Title: IVO Motor Replacement Part			
AG-SB-2021-08-B-EN	Effective Date: 06 Sep 2021	Compliance Category:	
Applicability		A - MANDATORY	
Aircraft type & model:	Affected Serial number(s):	B – RECOMMENDED	
All AutoGyro models	All AutoGyro models fitted with an IVO propeller	C - OPTIONAL	
The maintenance manual to be referenced is this stated or subsequent issue.		As per AutoGyro website	
This form is the response from AutoGyro GmbH either against a problem found in the product in service requiring a containment or rectification action, or as service information for aircraft modification incorporation.

Service Bulletin

Pic. 1

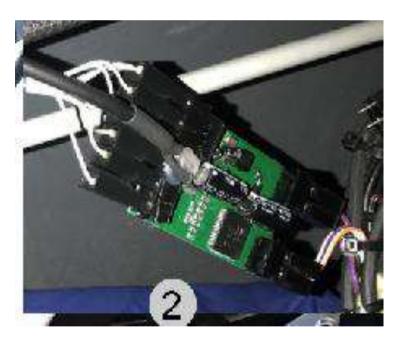
- 1. Remove the propeller spinner if fitted.
- 2. Replace the IVO propeller motor (Pic. 1) with the new version (48213) in accordance with 'RSUK0325 Issue 2 RotorSport IVO-prop Manual' available in the maintenance section of the AutoGyro home page.
